Advisory Action
Before the Filing of an Appeal Brief

Application No.

09/819,291

OZAKI ET AL.

FIG. 16

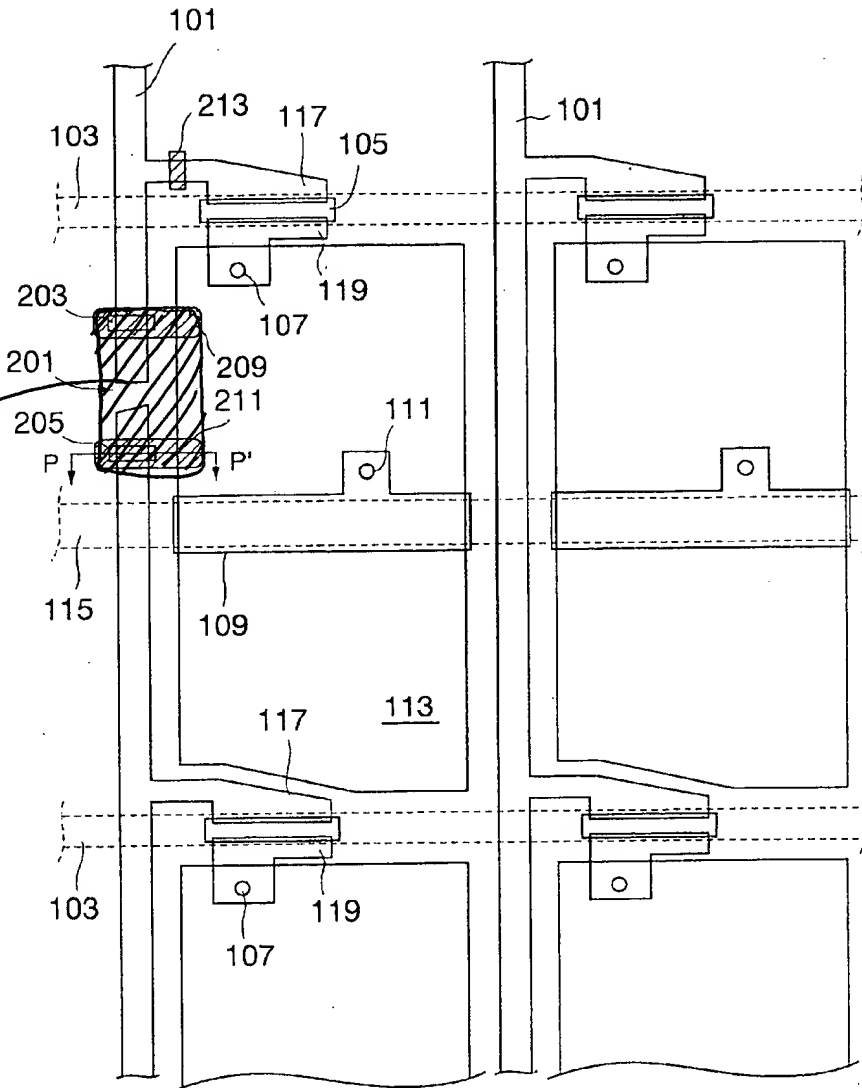
In Response E filed on 2/2/2007, applicants pointed out that Amendment filed on 11/21/2005 (not 11/14/2005) directed to Fig. 17B showing all the features from claim 40. However, Figs. 16-17 in example 1 shows that TWO disconnection repairing contact holes 203/205 are connected to each other by TWO conducting films 209/211, but not a (one) fourth conductive film as claim cited.

Applicants also pointed out that "conducting films 209/211 are simply never described to be necessarily formed from two separate conductive films" that means conducting film can be one film (see attachment), there is no such description of one conducting film filling "the disconnection repairing contact holes so as to reach a surface of the transparent glass substrate" in the specification. However, Example 2 shows (Fig. 18-19) that the one conducting film filling "the disconnection repairing contact holes" that do not reach a surface of the transparent glass substrate.

- * two conductive film filling the two the disconnection repairing contact holes so as to reach a surface of the transparent glass substrate in example 1 (Fig. 17 shows each conductive film fills each contact hole).
 - * one conductive film filling the two the disconnection repairing contact holes that do not reach a surface of the transparent glass substrate in example 2 (Fig. 19).
- being two independent features which CANNOT MIXED, and even one skilled in the art cannot combine.

one conductive layer fills the contact holes that reach a surface of substrate. This feature is not disclose anywhere in specification
